Re: Fourth Submission Review – Green Valley Ranch East Site Plan No. 15 - Site Plan and Plat
Application Number: **DA-1662-26**
Case Number(s): 2022-4014-00; 2022-3019-00

On behalf of Oakwood Homes, Aztec Consultants, Dewberry Engineering and Terracina Design, we have reviewed the comments dated February 17, 2023. The following is a response to comments.

Fourth Submission Review

DATE OF PREPARATION:	02-09-2022
SCALE:	N.T.S.
SHEET 2 OF 10

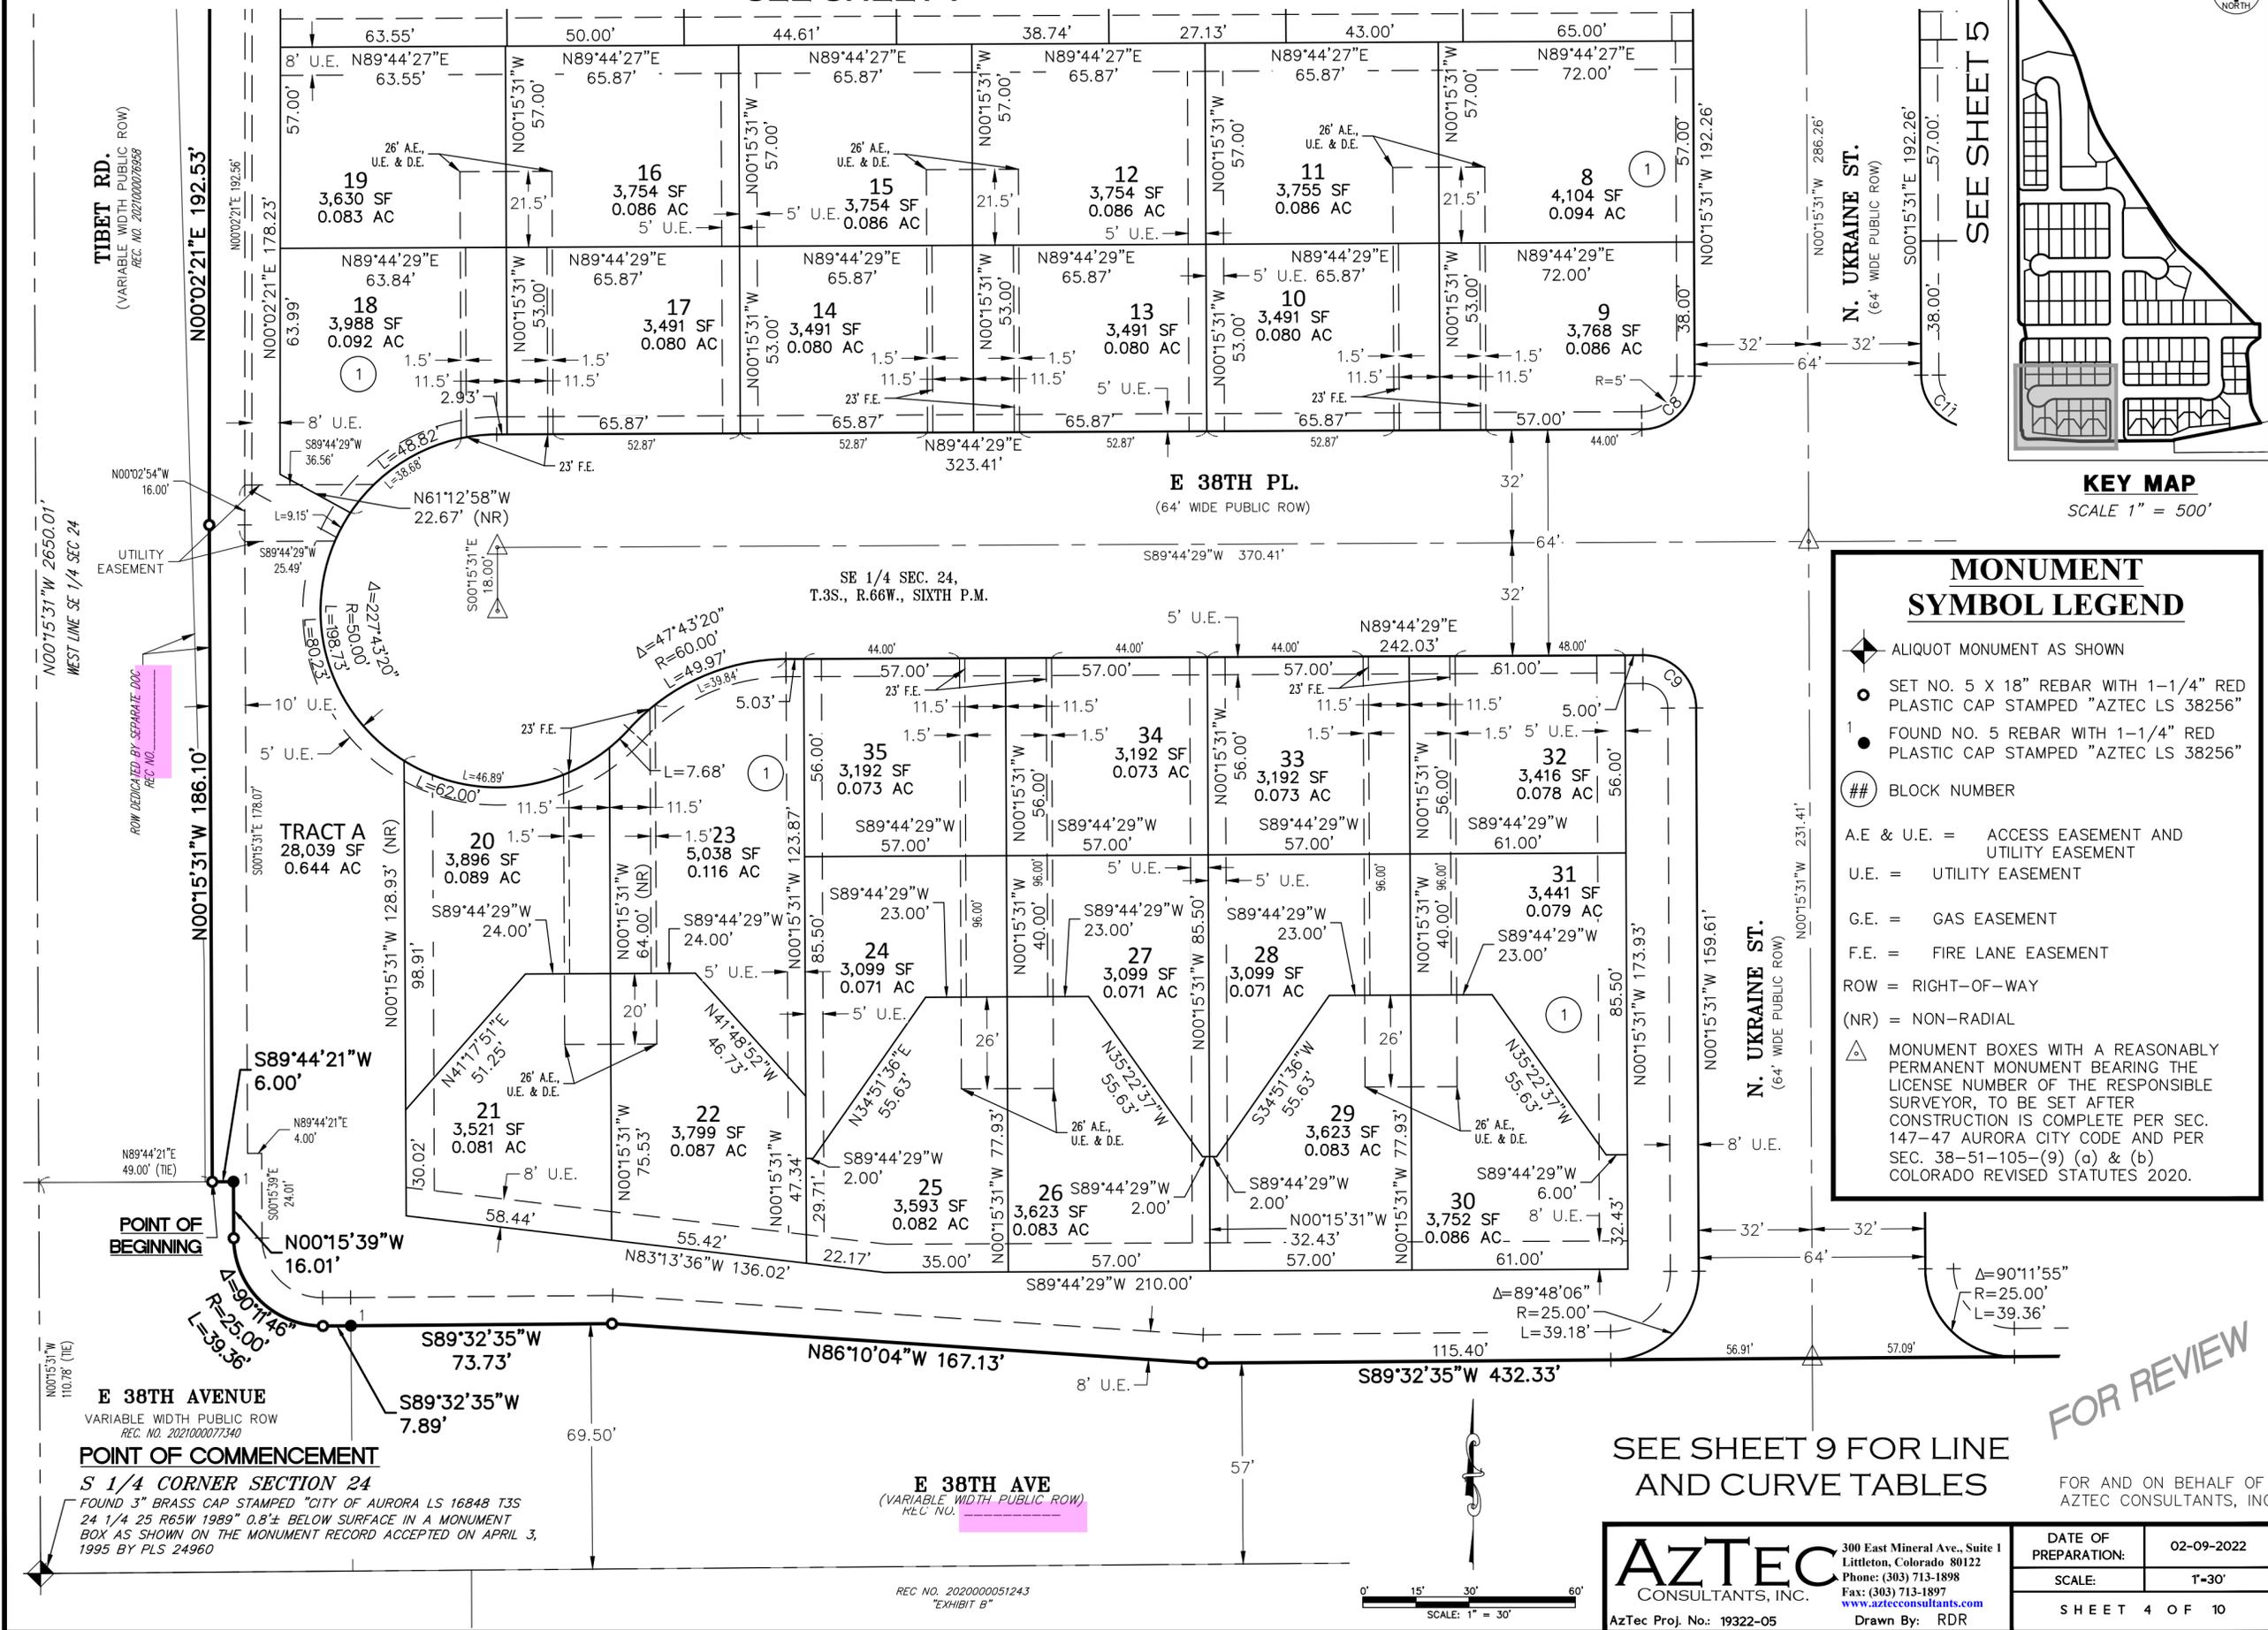
Graphics show 2021000076958?

Add space

Confirm area against revised closure report.

TYPICAL PORCHLIGHT MOTORCOURT
HOSEPULL

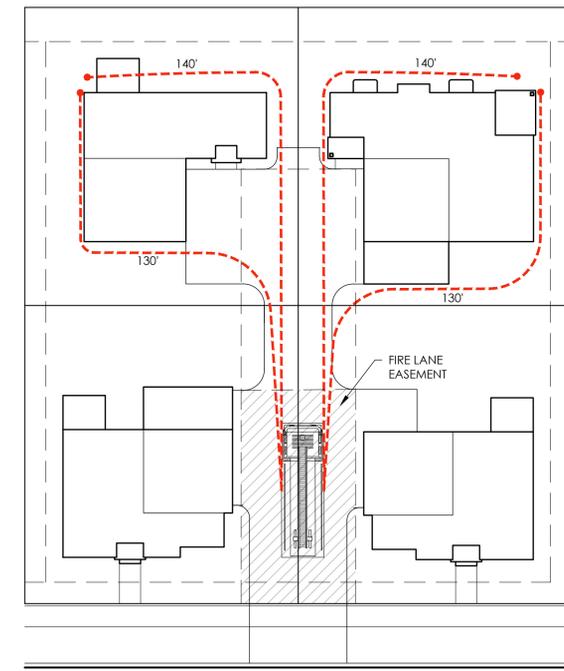
Pavers may require license agreement for pavers within easement? (Typical)

License agreements will be completed as necessary before the completion of the Civil CD's

Project Number: 50144653
 Designed By: JCM
 Drawn By: OCB
 Checked By: TDK
 Sheet Number: 16

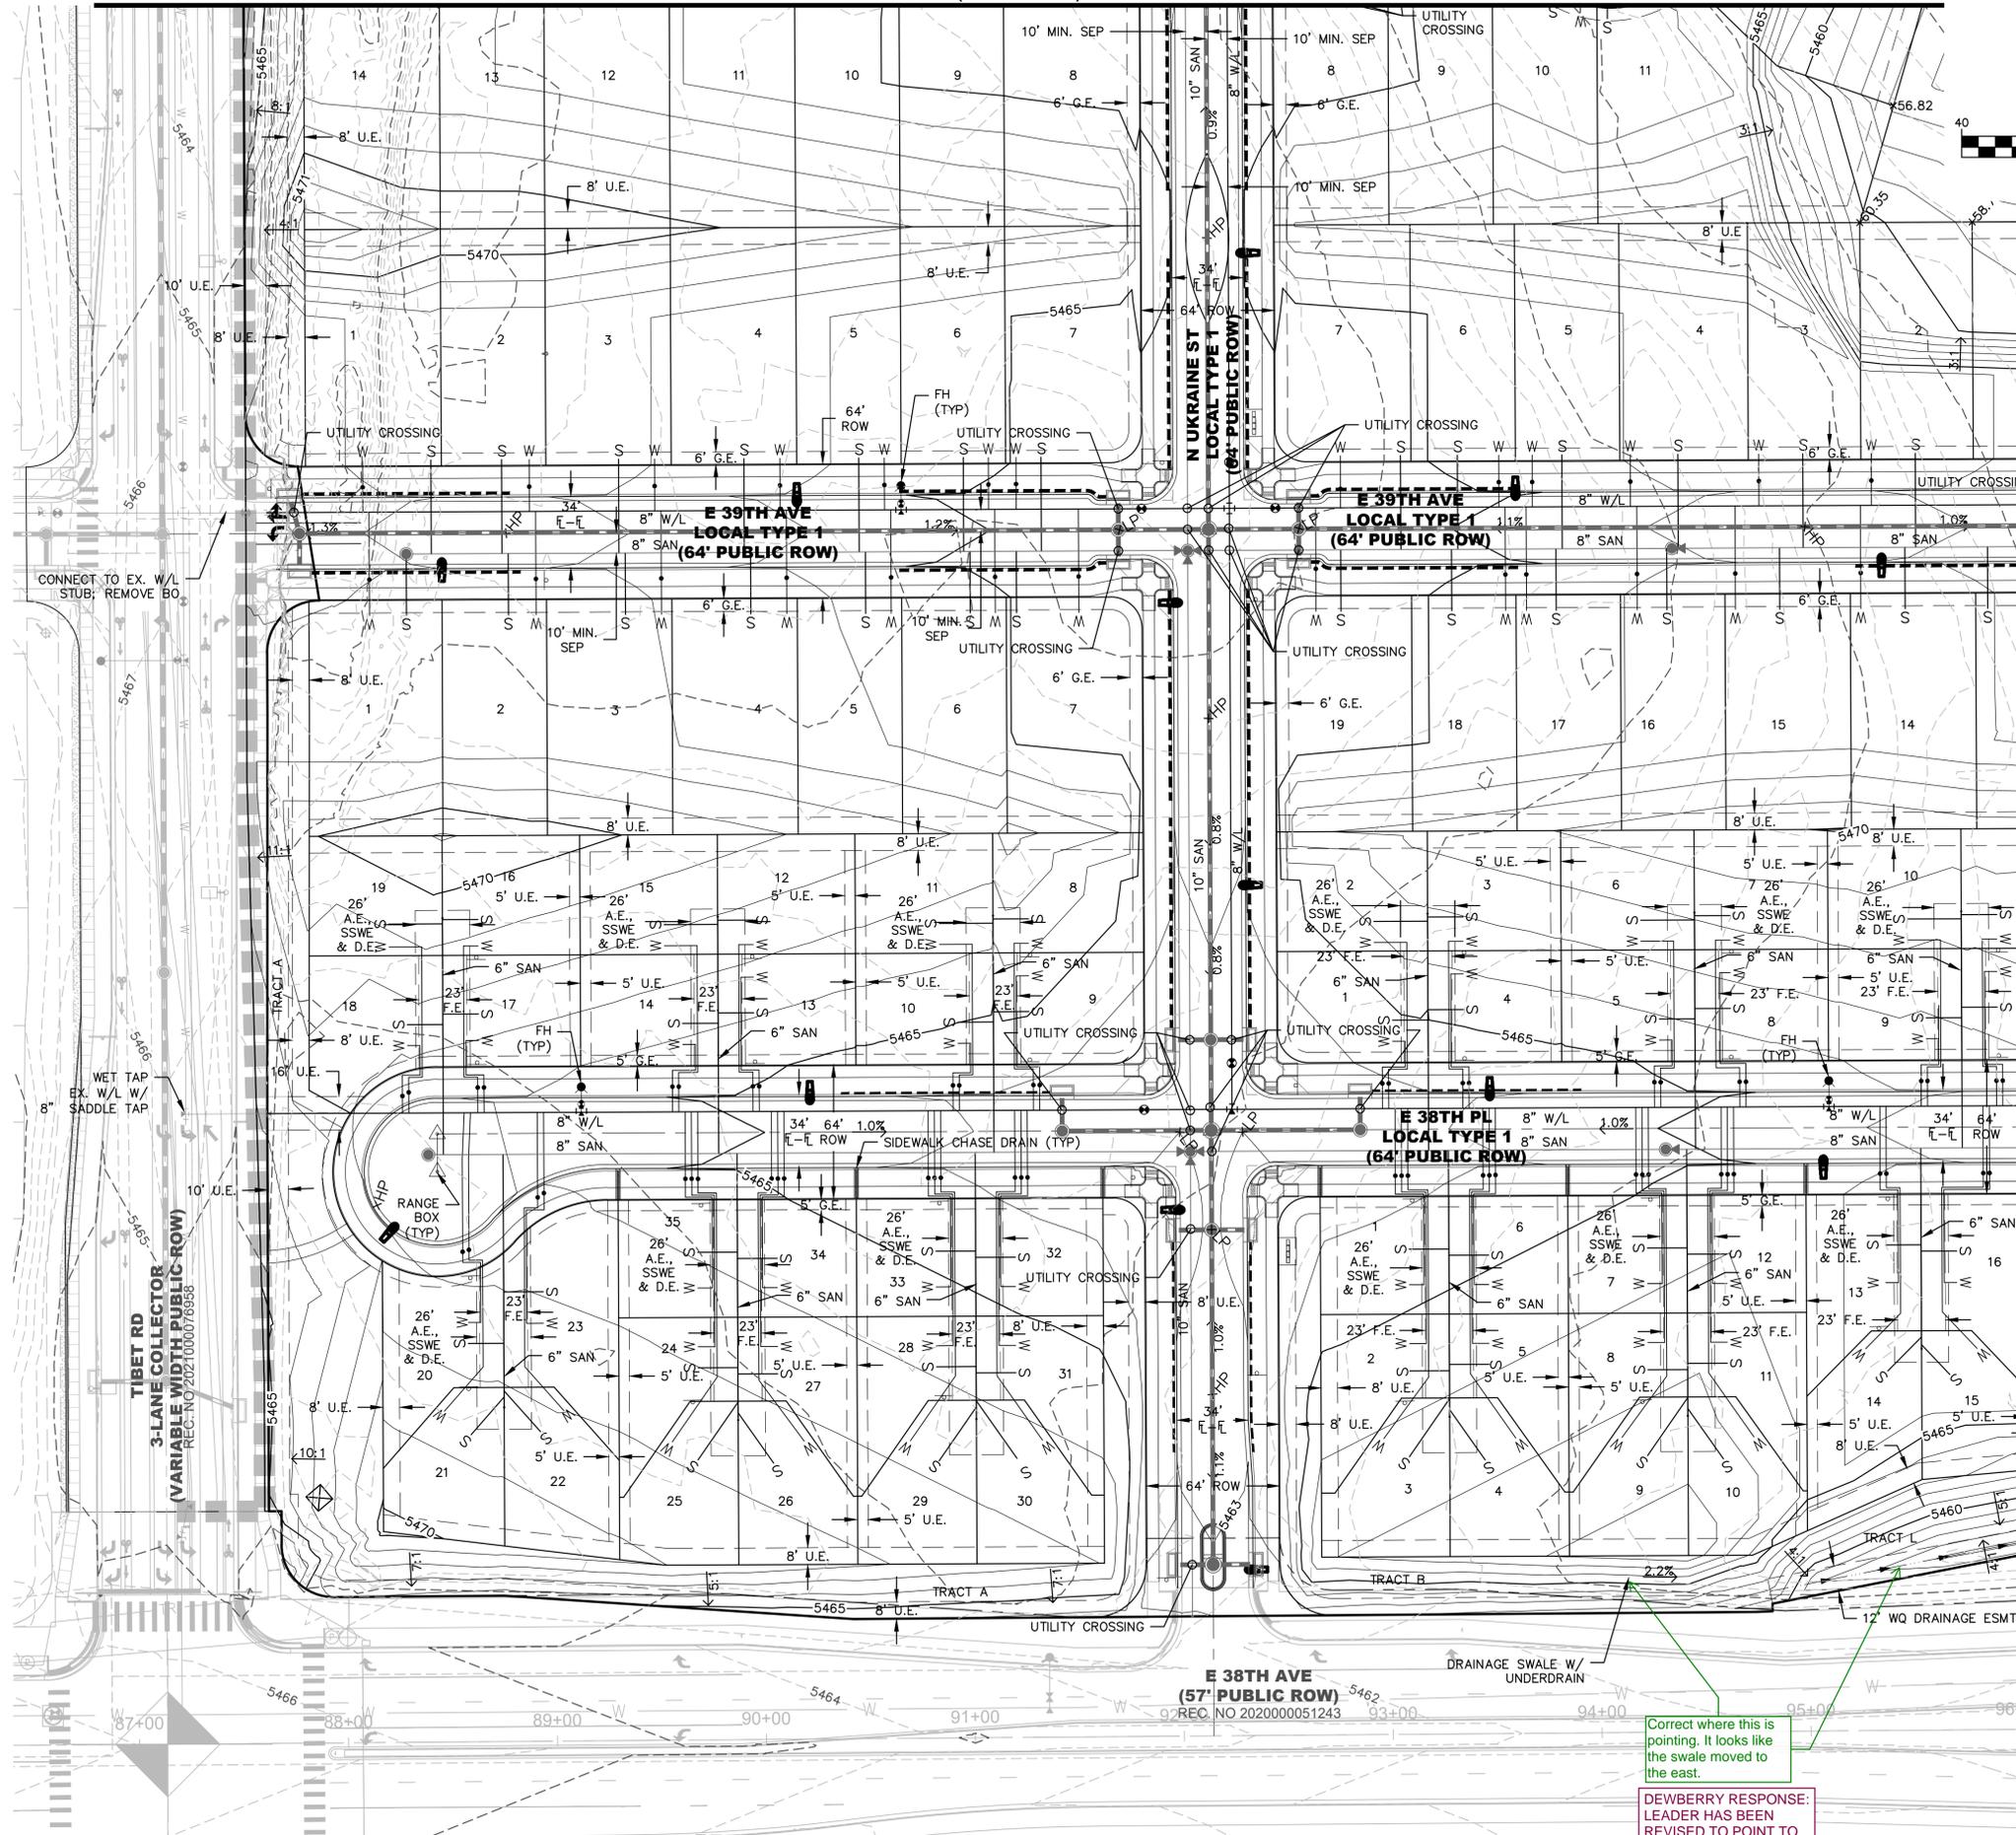
Correct where this is pointing. It looks like the swale moved to the east.

DEWBERRY RESPONSE: LEADER HAS BEEN REVISED TO POINT TO SWALE.

SINGLE FAMILY LANDSCAPE AREAS

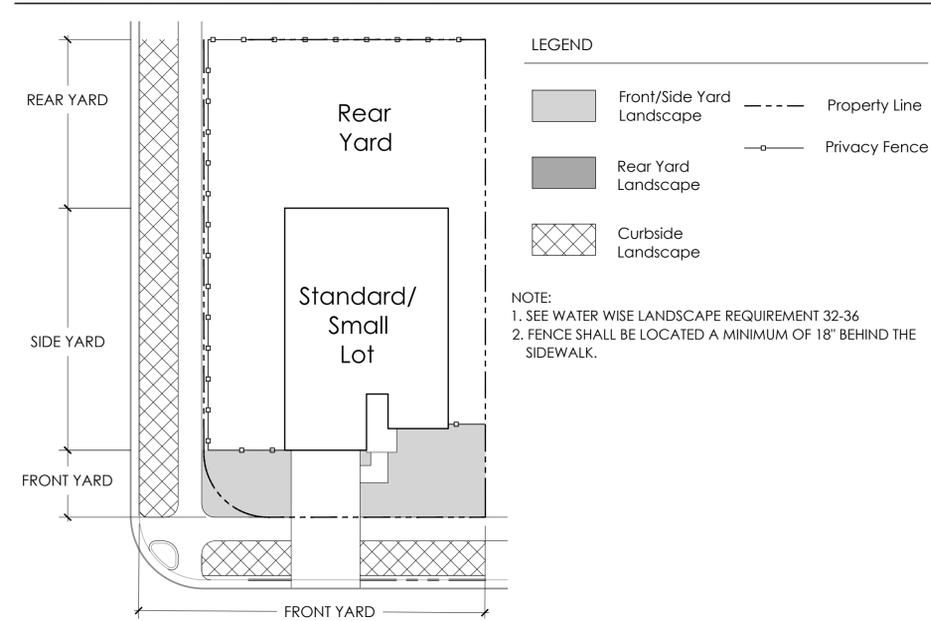
perennials may not be used as equivalents to meet screening requirements (Sec. 4.7.5.D.3.a.i)
 No more than 20 percent of the buffer plant material shall be ornamental grasses (Sec. 4.7.5.D.3.a.ii)

No Perennials are counted and no more than 20% of grasses to be counted towards overall requirements.
